Access Compliance Report

Public Rights-of-Way

Intersection ID: 10029989	Main Street: LANCASTER_HY	Cross Street: N/A	Location: NE
ADA ID: CF10ABA461B9	Ramp Type: ParaDiag	Initial Pass/Fail: Fail	Overall Compliance: No
		Severity Score: 12.5

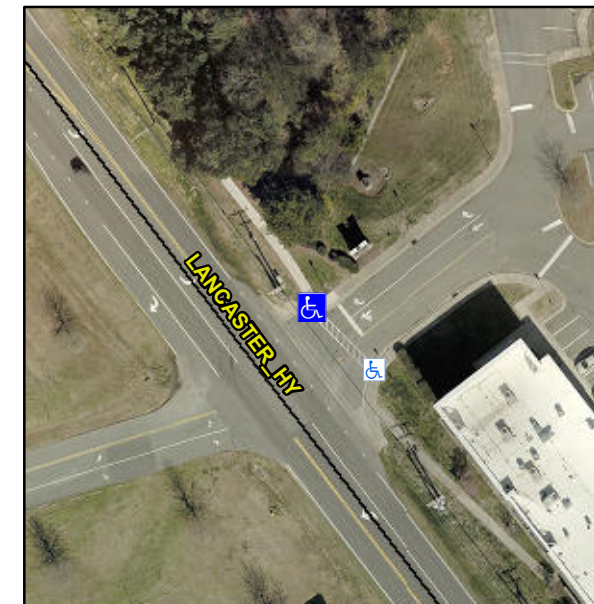
R304.3.2

Compliance	Description	Data	Compliance	Description	Data
N/A	Ramp Length LT (in)	59.0	N/A	Ramp Length RT (in)	61.0
Yes	Ramp Width LT (in)	60.0	Yes	Ramp Width RT (in)	59.0
Yes	Ramp Slope LT (%)	2.0	No	Ramp Slope RT (%)	10.0
Yes	Ramp XSlope LT (%)	1.2	Yes	Ramp XSlope RT (%)	0.0
N/A	Landing Length (in)	N/A	N/A	DWS Provided?	N/A
N/A	Landing Width (in)	N/A	N/A	DWS Contrast?	N/A
N/A	Landing Slope (%)	N/A	N/A	DWS Length (in)	N/A
N/A	Landing X Slope (%)	N/A	N/A	DWS Full Width?	N/A
N/A	Landing Curb? (Y/N)	N/A	N/A	DWS Offset (in)	N/A
N/A	Shared Landing?	N/A			
N/A	Gutter Ponding?	N/A	N/A	Gutter Slope (%)	N/A
N/A	Gutter Lip Ht (in)	N/A	N/A	Gutter X Slope (%)	N/A
N/A	Painted X Walk1?	No	N/A	Painted X Walk2?	Yes
	X Walk 1 Direction	To W		X Walk 2 Direction	To SE
N/A	X Walk 1 Width (in)	N/A	N/A	X Walk 2 Width (in)	52.0
	X Walk 1 Slope (%)	8.5		X Walk 2 Slope (%)	0.5
	X Walk 1 X Slope (%)	3.4		X Walk 2 X Slope (%)	5.5
N/A	Ramp inside XWalk1?	N/A	N/A	Ramp inside XWalk2?	Yes

Remove & Replace Curb Ramp With Two New Directional Ramps or Equivalent.
